Construction Division
Additions & Alteration Charges Approval Form

GULMOHAR RESIDENCY

Details of Additions & Alterations

Description	Direction	Owners & Developers :	Date :	Promoted by
WORKING PLAN-1660 Sft-BI TYPE		Modi Reality Mallapur LLP	25.09.2020	Modi Properties Pvt Ltd
		Project Name & Phase :	Prepared By :	Modi Properties Pvt Ltd
		Gulmohar Residency	Approved By :	Modi Properties Pvt Ltd
			Scale :	Phone: +91-40-66335551

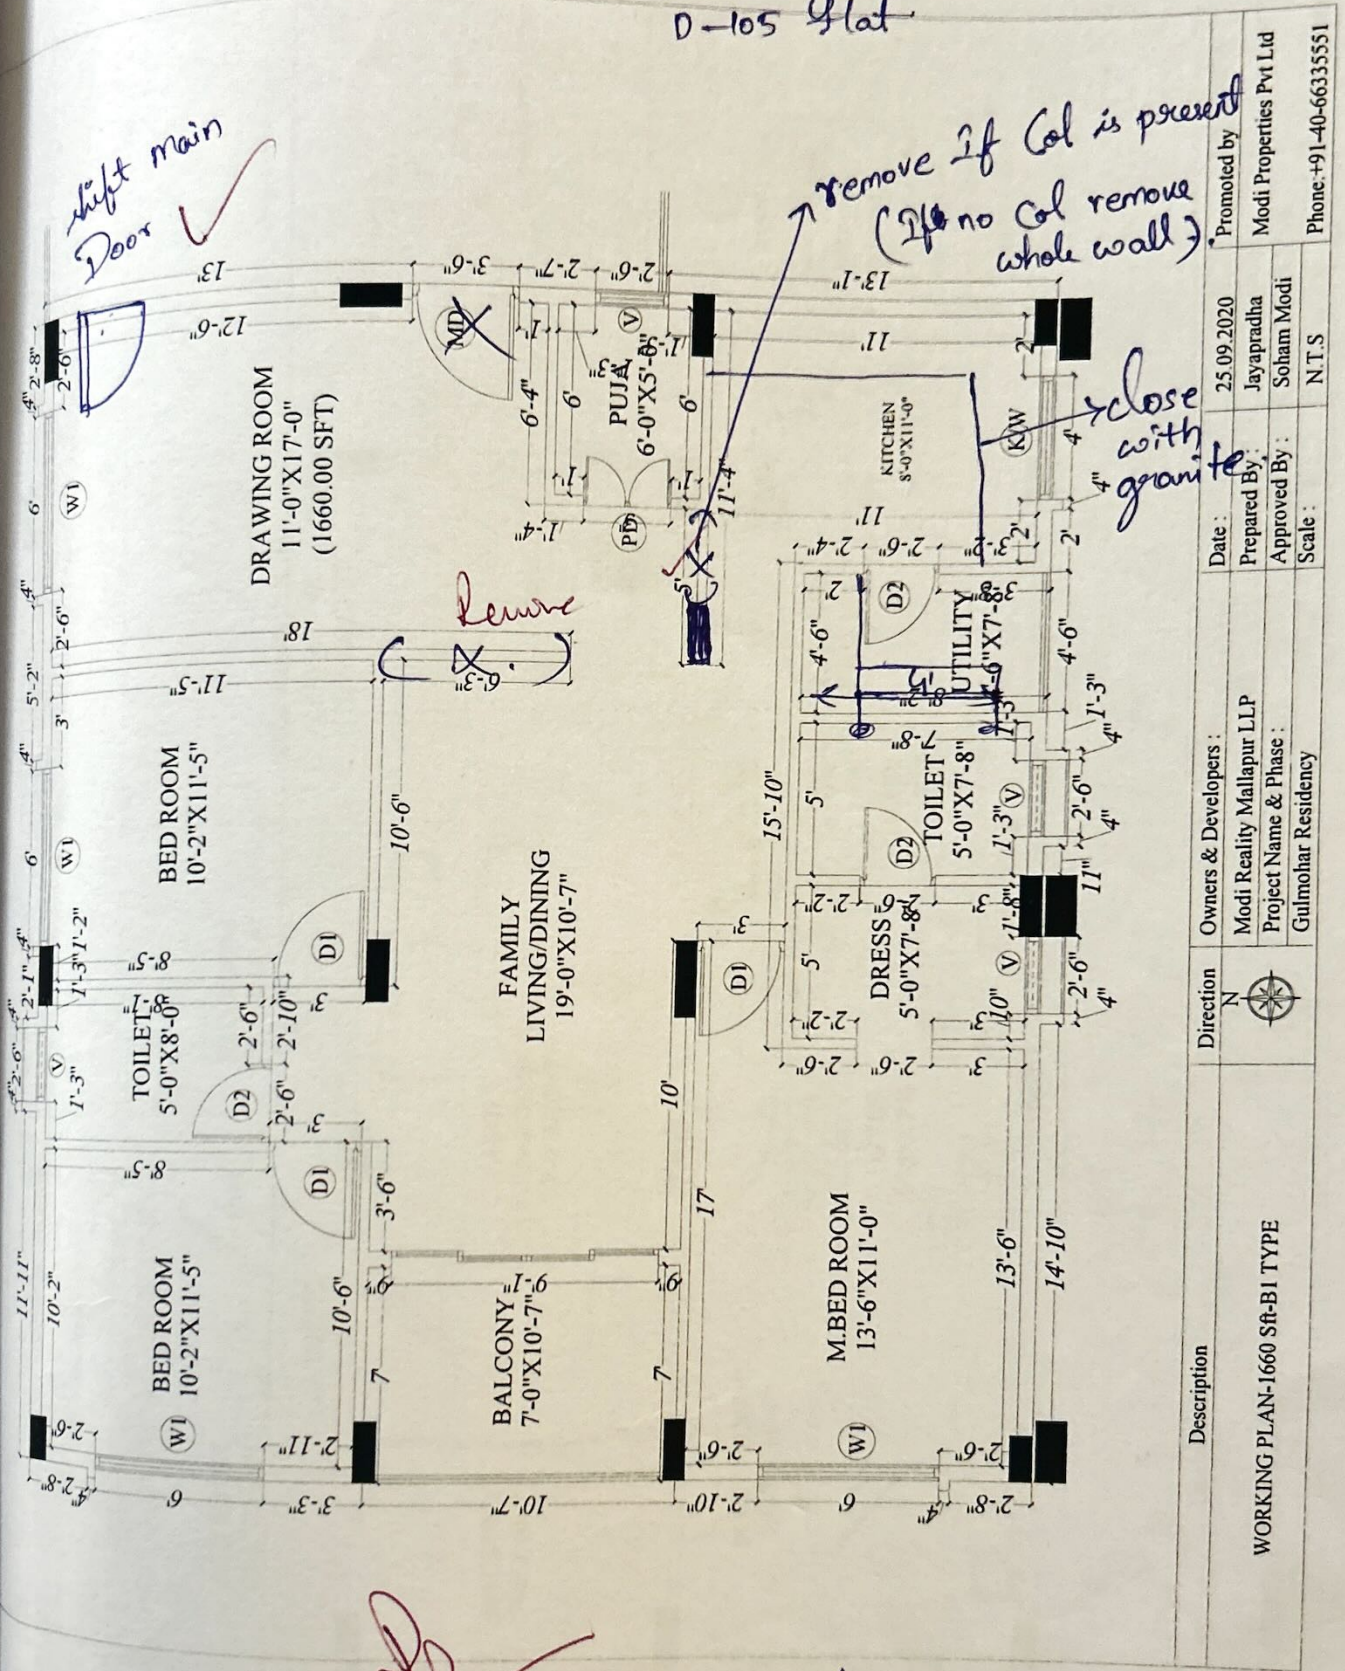
- ② Extra wash basin in Dining room as
shown in plan

- ① Leave wall ^{opening} for window. A.C. in children B.R.
- ② False Ceiling in Hall, Dining & Passage areas
+ give estimate for B/R false roof

~~Kitchen~~ room granite racks as per.
D-105 flat

Shift main
Door ✓

Remove if Col is present
(If no Col remove
whole wall)

close
with
granite

Remove

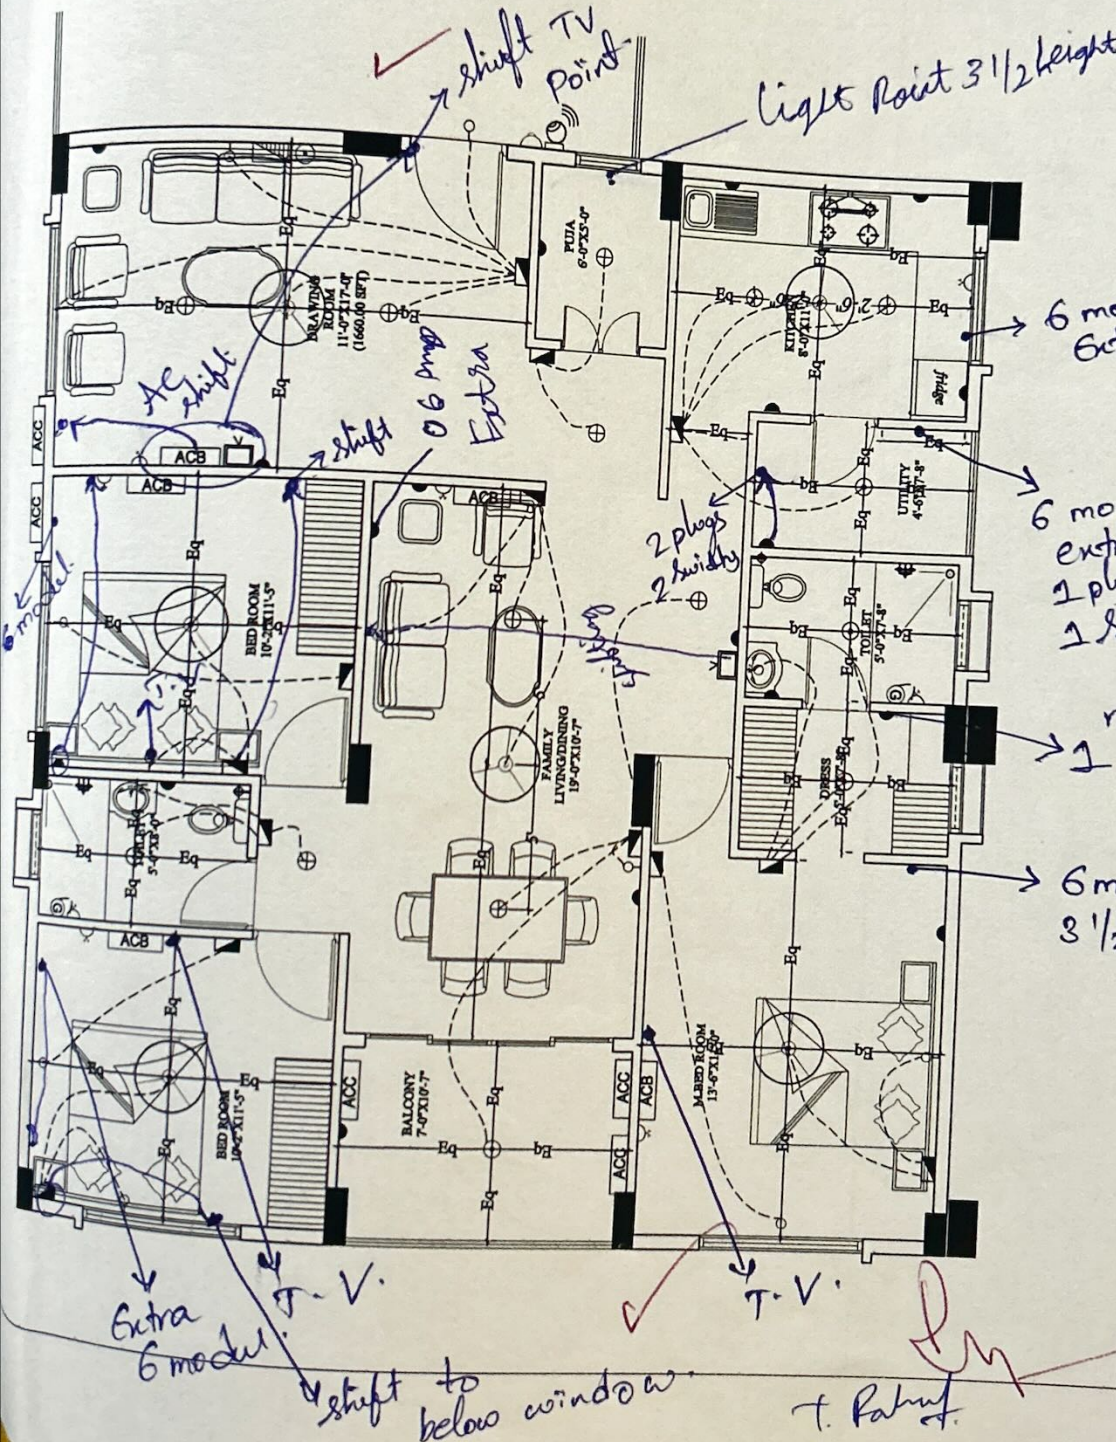
- ① Electrical Points shifting & charging.
as per shown in plan.

As per D-105 flat
